STAFF REPORT

PLANNING & ZONING COMMISSION

1. SKETCH PLAN REVIEW II

2. PRELIMINARY DEVELOPMENT PLAN REVIEW

Image 3 – Today's Proposed Plan

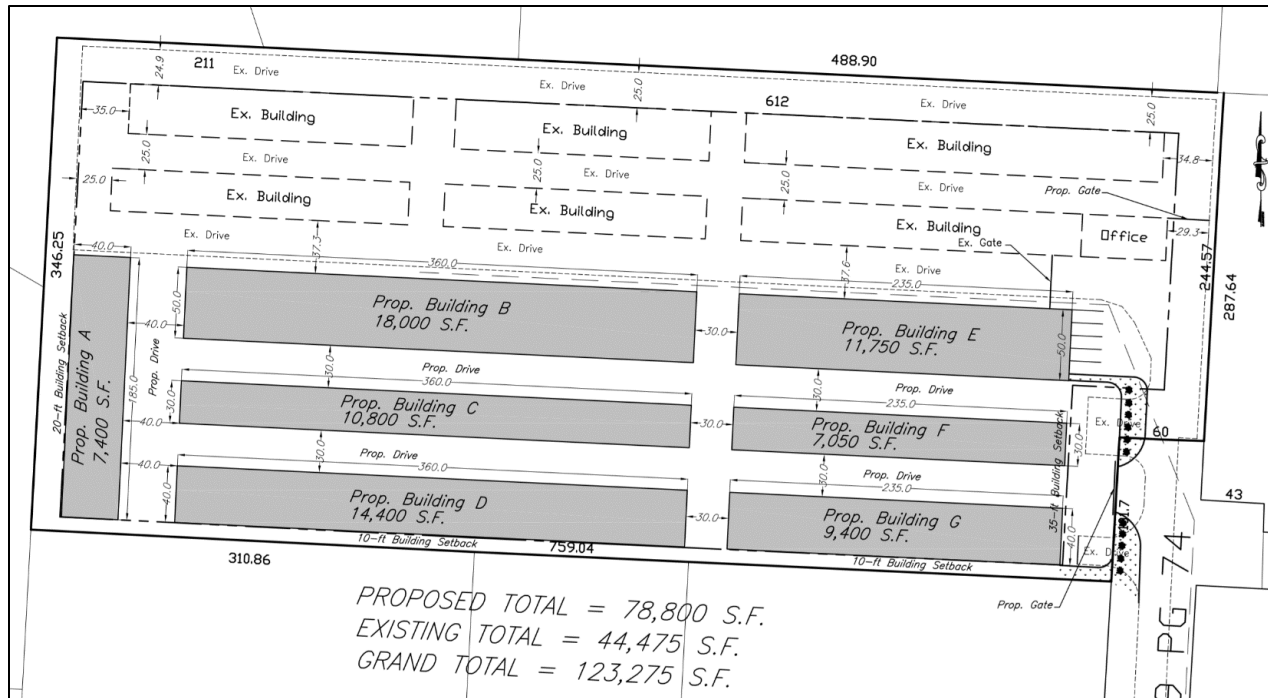
The proposal remains the same, to build new buildings and the removal of boat and RV storage from the site. The site plan below (Image 3) shows the construction of seven new structures with no parking for recreational vehicles. Not shown on the image is the removal of one structure in order to build the proposed buildings.

Staff's request to have the divergences in the development text were not included in this packet. However, seeing as though they are minimal in nature and can be provided at the final development plan review, staff sees no reason to hold up the process. Staff would, however, recommend that the applicant provide the divergences in a development text for the next submission. For the sake of the preliminary review, staff will outline the two divergences required: 1) the proposal has a lot coverage of 42.6% (78,000 square feet/185,000 square feet). This coverage is

higher than the code maximum lot coverage of 20%. However, staff has no issue with this divergence as the overall intensity of the site is not overwhelming due to the type of use proposed.

Staff met with the applicant's engineers to discuss updates to the site's current storm water management system and the need for improvements to meet the City of Powell's Storm Water Management Criteria as well as the Ohio EPA's General Construction Permit requirements. As of this proposal, the applicant does not meet the minimum requirements. However, the applicant and their engineer stated that they would work toward a solution for the next submission.

Overall, staff is in favor of this development. The construction of new storage buildings adds additional service to Powell residents and the construction of new buildings, as well as the removal of outdoor parking, will help lessen the visual impact to neighboring commercial and residential uses. Instead of seeing parked recreational vehicles, neighbors will see new and well-designed buildings. Also, the new buildings will help "fence off" the site and block it from the street. Thereby further lessening the impact of the site on neighboring uses. Lastly, the number and spacing of the buildings also seem reasonable as it is a more efficient use of site. The only issues from Staff's standpoint is that there will be Divergences to the Planned Industrial code as it relates to building coverage and total coverage by building and pavement, which should be set forth within the Development Plan text when submitted.

1. A development text is provided at the final development plan listing all divergences.
2. All Engineering department comments are addressed before the final submission.
3. The applicant clarifies the expected date of completion in the next submission.
